**S E R V I C E N O T E**

Supersedes:  
E8363A-03

E8363A PNA Microwave Network Analyzers

Serial Numbers: US00000000/US99999999 and MY00000000/MY00000000 [All]

**Figure 1:** A3 Front Panel Interface Board Assy without the Bracket

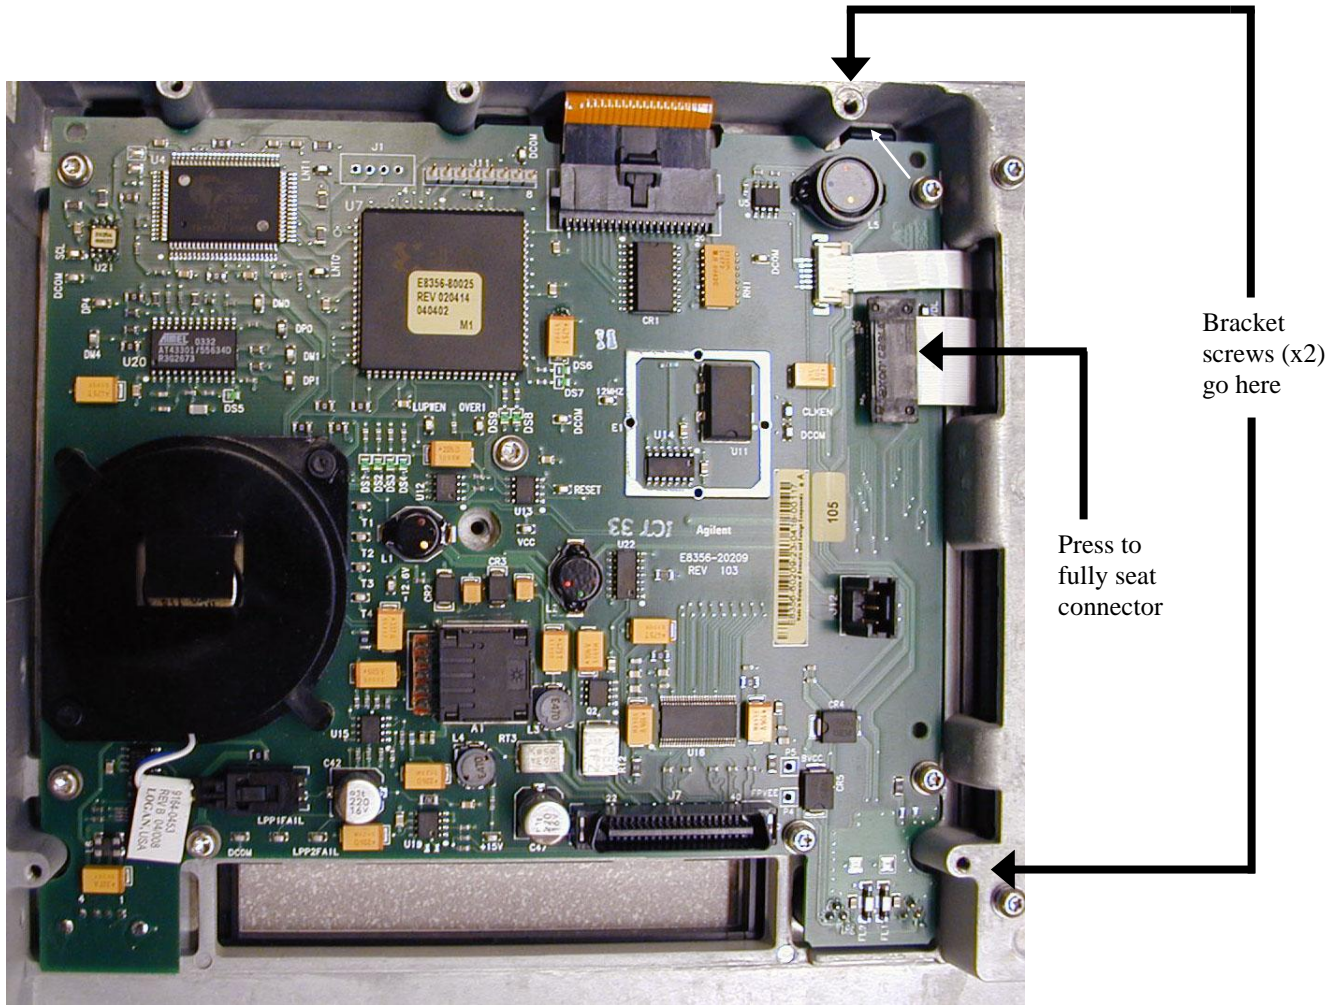
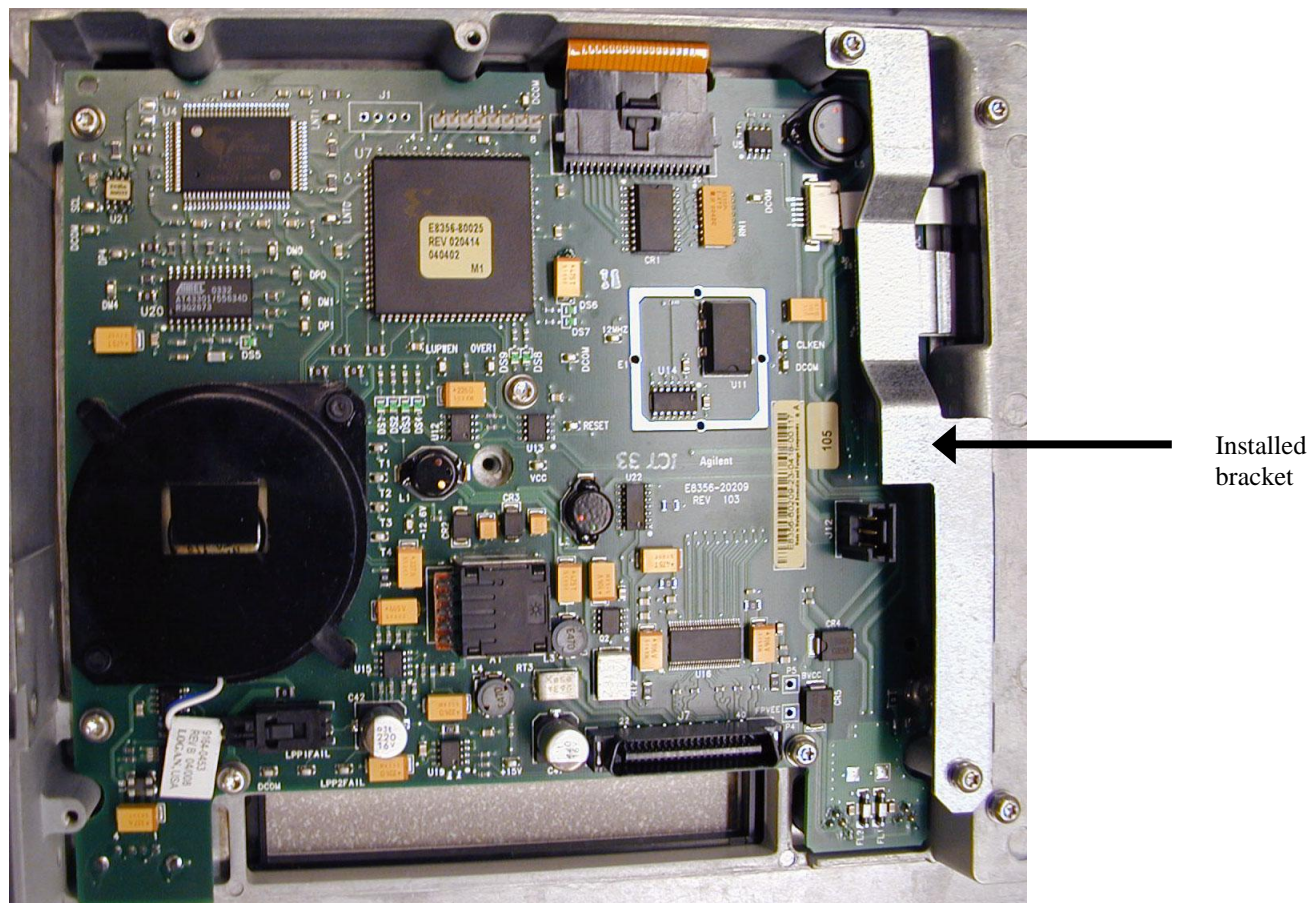
A connector of the ribbon cable (Agilent part number 8120-8409) that joins the front panel display to the front panel interface board can loosen, causing a display failure, unless a new bracket is installed. Because the failure rate has been very low, it is recommended that the bracket be installed only when there is an additional reason to remove the PNA front panel.

1. Refer to Figure 1 in this document:
  - Press down firmly on the ribbon cable's black connector.
  - Locate the two tapped holes for the bracket screws.
2. As shown in Figure 2 in this document, position the bracket so that its holes line-up with the two holes you located in the previous step.
3. Hand-start the two screws, and then torque both to 9 in-lbs.
4. Reinstall the PNA Front Panel by following the Service Guide instructions in the "Replacement Procedure." This is located on the same page as the "Removal Procedure" used previously in step 7.
